**From:** Dario Schioppa <dschioppa@tesla.com>  
**Sent:** 24 October 2023 20:42  
**Subject:** Annex 7 - Feedback

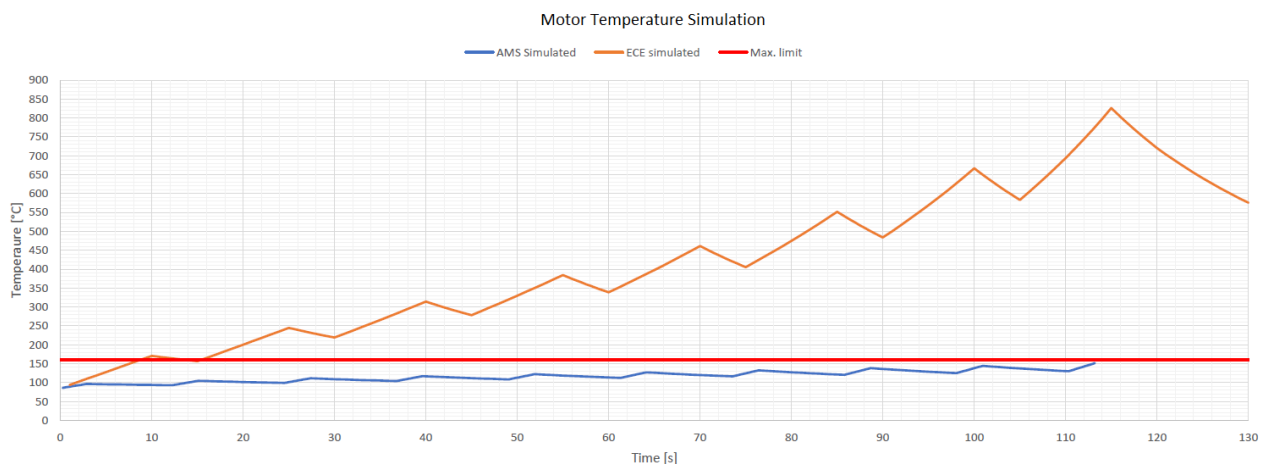
First off, inspection of the simplified summary parameters of the 2 cycles will yield that electrical components would be subject to a more severe duty cycle. For example, for an EV currently in production:

Further confirmation comes from thermal simulations conducted on any electrical component. In the example that follows, the motor windings of the EMB would experience the following temperatures when subject to 8+1 static test:

Max limit = what a design engineer may identify as a reasonable temperature specification for electrical components after conducting harsh performance cycle simulations.

My recommendation to rectify the current situation is to adopt all of the following:

- Decrease duty cycle with increased breaks between applies, the duration of which may be left up to the discretion of the manufacturer to avoid permanent HW damage
- Allow SW limitations that either restrict the clampforce to the one necessary to achieve Type-0 performance or at least avoid using fade clampforce headroom in static conditions
- Parametrize duration of full throttle event based on actual vehicle  $V_{max}$  and achievable deceleration
